| Contract: Blanchard Street Pumping Station Modifications | Owner: City of Wauwatosa |

Description:

Change Order #2

SECTION 4
SCALE 3/8" = 1'-0"

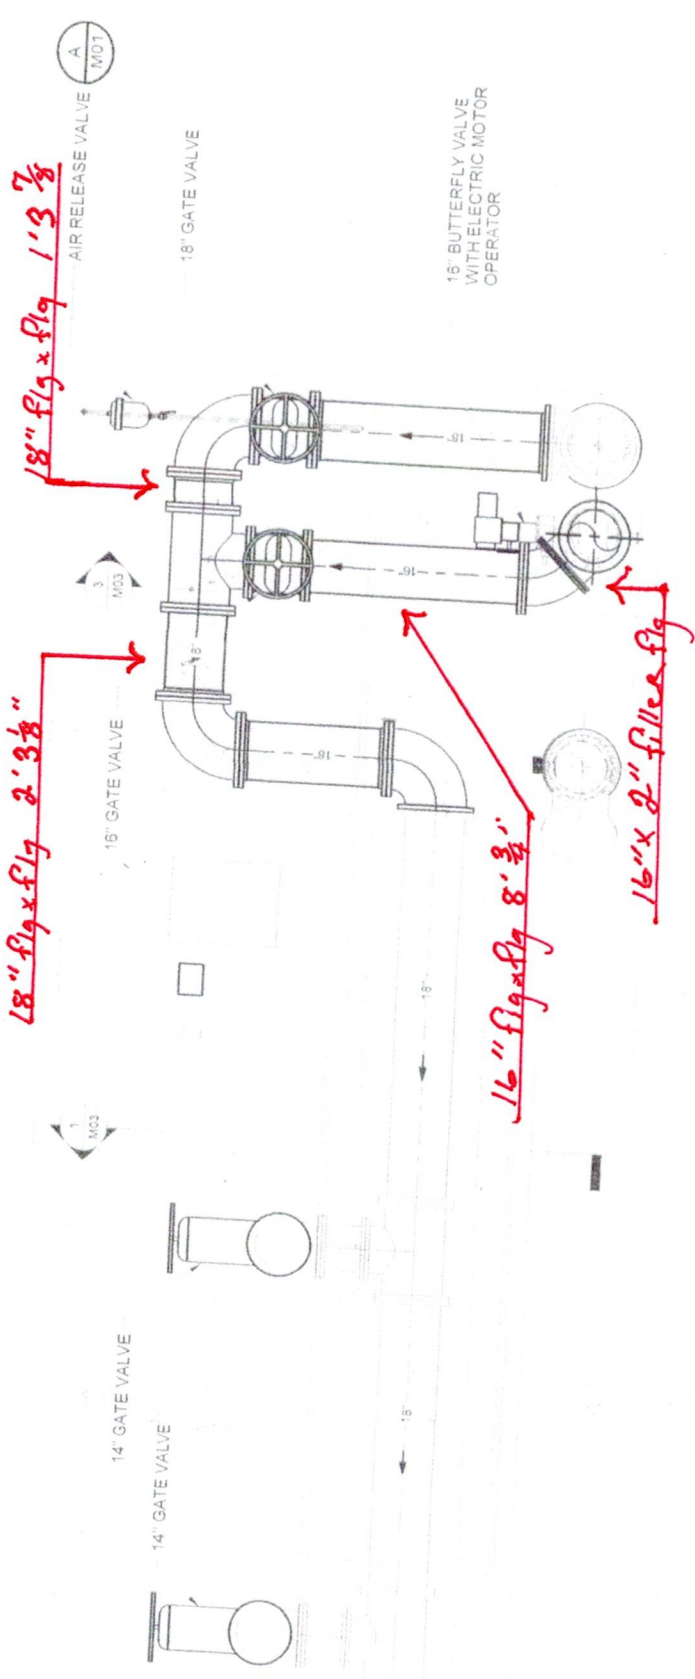
- The new pumps provided for pump designations 4 and 5 are mounted on steel skids with a higher elevation than the existing pumps which didn't allow for the existing process pipe to align with the new pumps. This required cutting of the existing concrete pump bases and piping modifications to align the existing process piping to the new pumps. This change order covers the cost for the equipment, parts, and labor to perform the pump base and process pipe modifications.

- During installation of the process pipe in the lower level, it was determined that the process piping alignment would interfere with an existing steel support beam. Additional piping modifications will need to be made to realign the process piping around the beam. This change order covers the cost for additional pipe, fittings, and labor for the realignment of the process piping.

- Additional process piping modifications were required to allow for the installation and alignment for new pumps 1 and 2. This required additional pipe and uni-flanges to be provided. This change order covers the cost for the additional pipe, fittings, and labor for the piping modifications.
